DART SERVICE INSTRUCTION

TO AMEND INSTRUCTIONS FOR CONTINUED AIRWORTHINESS

ICA-D350-794 REV. 6 OR EARLIER

The purpose of this Dart Service Instruction is to amend hardware changes to tank assembly D350-794-141 at change 002 and subsequent.

ICA FIGURE 28-2 IS

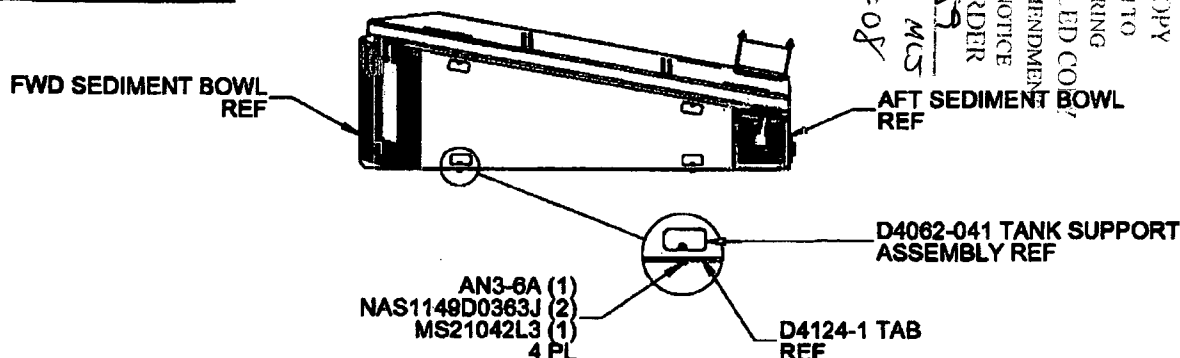
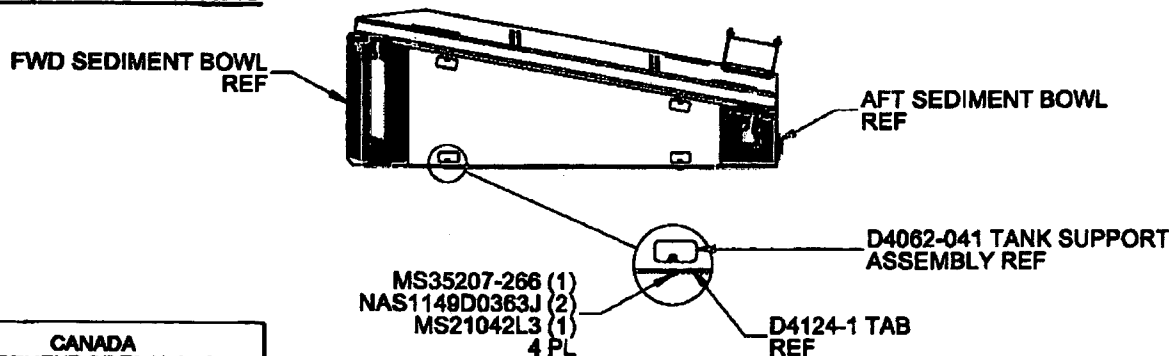
The NAS1149D0363J washers under the AN3H5A bolts have been replaced by NAS1149D0332J washers to allow greater thread grip. The MS35207-266 screws have been replaced by AN3-8A bolts to prevent the screw heads from becoming stripped during installation.

Revise ICA-D350-794 Figure 28-2 and Figure 28-3 as follows:
